Rezoning Application: PD 23-0882
Zoning Hearing Master Date: January 16, 2024
BOCC Land Use Meeting Date: March 19, 2024

REVISED REPORT

2.4 Proposed Site Plan (partial provided below for size and orientation purposes. See Section 8.0 for full site plan)

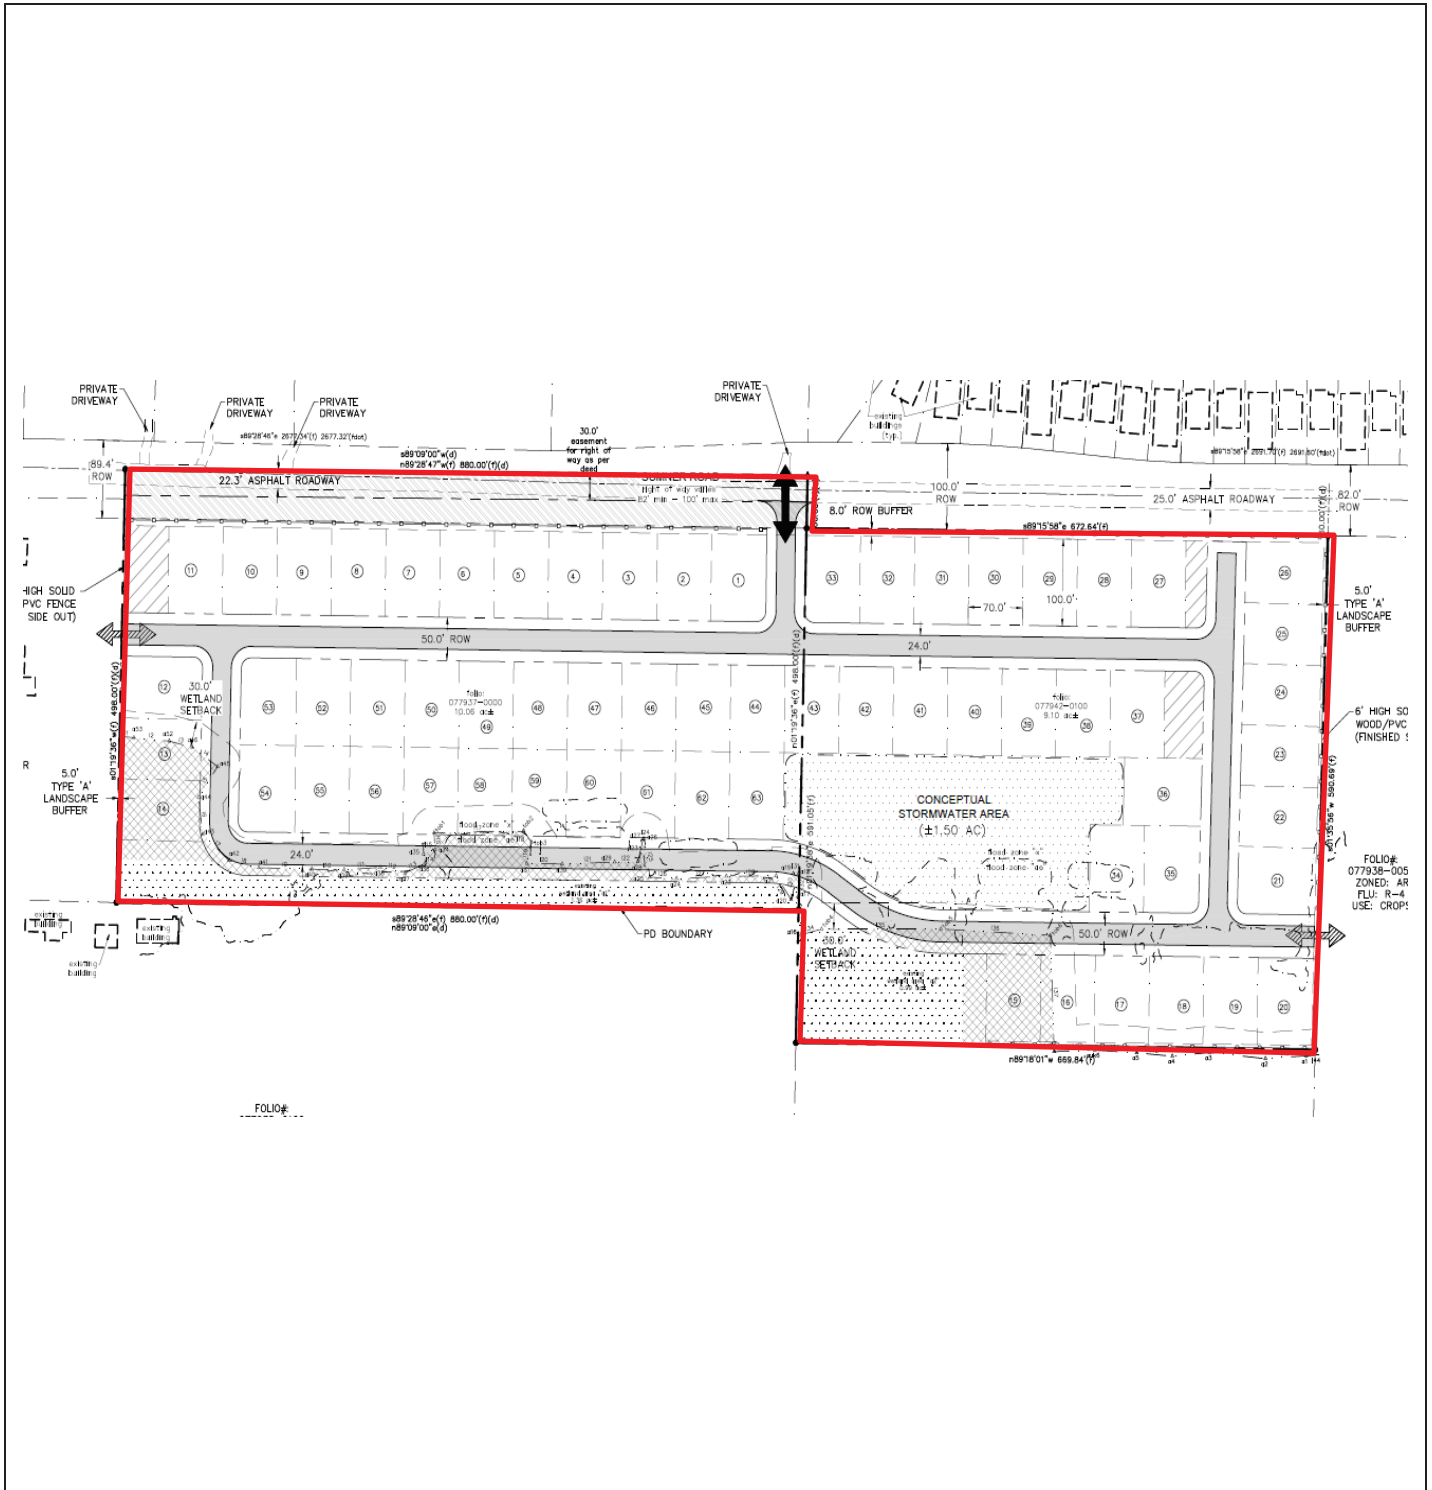
5. Prior to the issuance of any building or land alteration permits or other development, the approved wetland / other surface water (OSW) line must be incorporated into the site plan. The wetland/ OSW line must appear on all site plans, labeled as "EPC Wetland Line", and the wetland must be labeled as "Wetland Conservation Area" pursuant to the Hillsborough County Land Development Code (LDC).

7. Wetlands or other surface waters are considered Environmentally Sensitive Areas and are subject to Conservation Area and Preservation Area setbacks. A minimum setback must be maintained around these areas which shall be designated on all future plan submittals. Only items explicitly stated in the condition of approval or items allowed per the LDC may be placed within the wetland setback. Proposed land alterations are restricted within the wetland setback areas.

- 7.1. A 30' wetland setback will be required from the limits of any approved wetland impacts. The southern road will be located within the 30' wetland setback area in the configuration shown on the current plans and may need to be relocated and/or compensation may be required.

11. The project shall be served by, and limited to, one (1) vehicular access connection to Sumner Rd. Additionally, the developer shall construct one (1) vehicular and pedestrian access stubout along the eastern project boundary, and one (1) vehicular and pedestrian access stubout along the western project boundary. Such connections shall be construction in the locations shown on the PD site plan.

14. Prior to or concurrent with the initial increment of development, the property owner shall dedicate and convey to Hillsborough County +/- 60-feet of right-of-way along a portion of their Sumner Rd. frontage, as generally shown on the site plan. The intent of this condition is to convey the underlying fee for certain lands owned by the applicant and upon which the existing Sumner Rd. encroaches, and which would contribute a portion of the lands necessary to ensure Sumner Rd. could be improved (by others) to the full Typical Section – 7 (TS-7) standard in the future.

TYPICAL SECTION

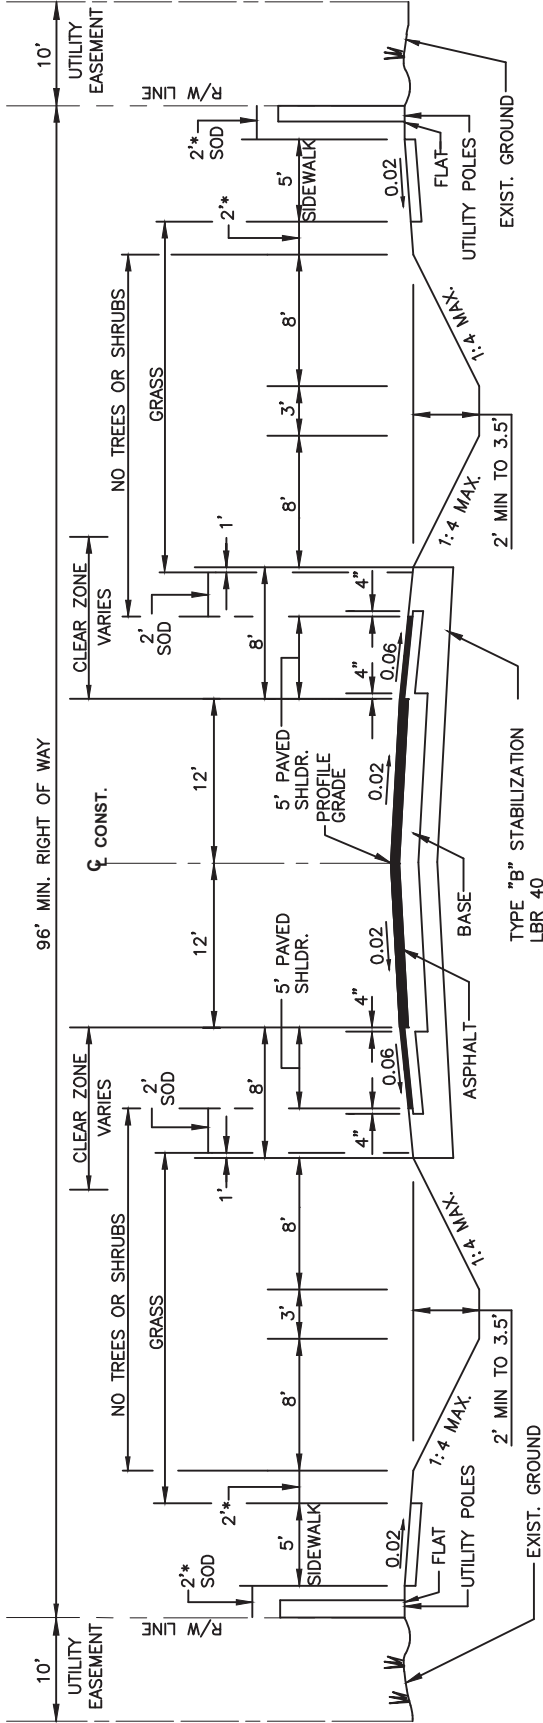
Support: Due to the limited space between the existing edge of pavement and R/W line, there is not enough room to construct the drainage swales per TS-7 with 19' wide ditches (2' deep, 4:1 side slopes, 3' flat bottom). The proposed design will still satisfy the conveyance requirements from the runoff of the limited contributing area without adversely affecting upstream or downstream conditions. This modification is still in compliance with intent for roadside ditches as the flow capacity of the proposed ditch exceeds the design capacity for the contributing areas as determined utilizing the Manning's Formula (specified in Section 11.1.3.1 of the Hillsborough County Stormwater Technical Manual). Therefore, and 8' wide ditch with 4:1 side slopes and "V" bottom is requested where there are existing ditches.
